# Work Order ID 65384

Item Name: Aft Crosstube Support Change

# DART SERVICE INSTRUCTION

TO AMEND INSTALLATION INSTRUCTIONS IIN-D205-594 Rev. C (AND EARLIER) AND INSTRUCTIONS FOR CONTINUED AIRWORTHINESS ICA-D205-594 Rev. 2 (AND EARLIER)  
REF. CANADIAN STC: SH03-6 REFERENCE ONLY  
REF. FAA STC: SR01742NY

**FIGURE 1: INSTALLATION OF SUPPORT ON CROSSTUBE**

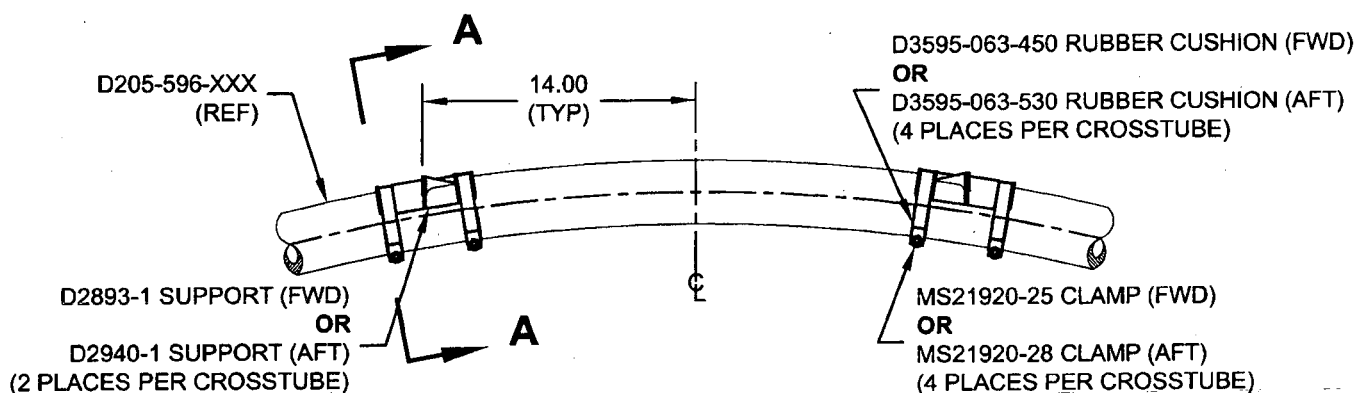
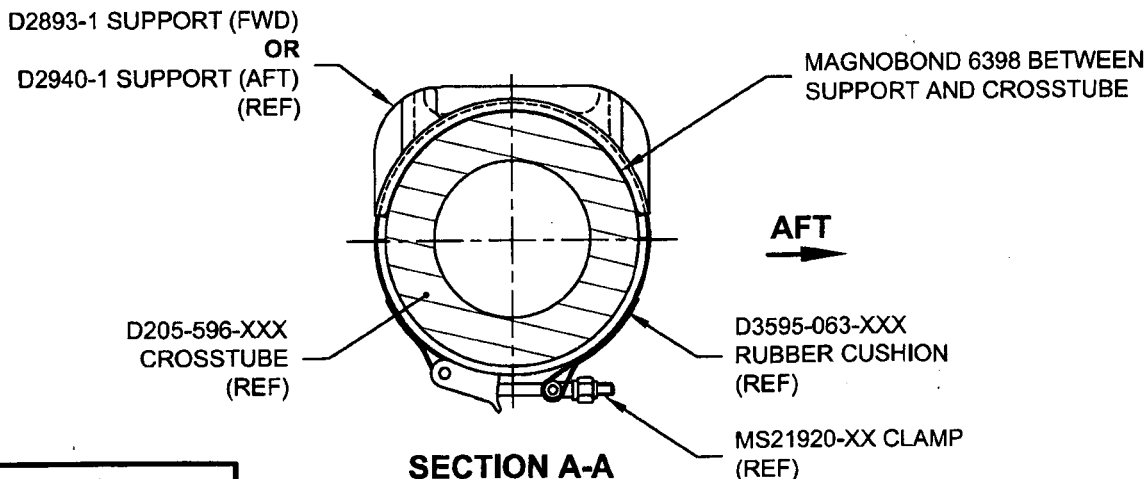
- 7) Apply a 0.03" to 0.06" thick layer of Magnobond 6398 underneath D2893-1 or D2940-1 Supports and re-install the Supports on the crosstube as shown in Figure 1. Install a D3595-063-450/-530 Rubber Cushion on each MS21920-25/-28 Clamp. Position and secure the D2893-1 or D2940-1 Supports on the crosstube using MS21920-25/-28 Clamps. Torque clamps to 80-100 in-lb. Let the D205-596-101/-103/-105/-107 Crosstube Assembly cure before re-installing the crosstube on the aircraft.

**Note:** It is acceptable to substitute the MS21920-25/-28 with longer or shorter clamps to accommodate varying diameters. Ensure there is a minimum of 1.5 threads in safety on the nut.
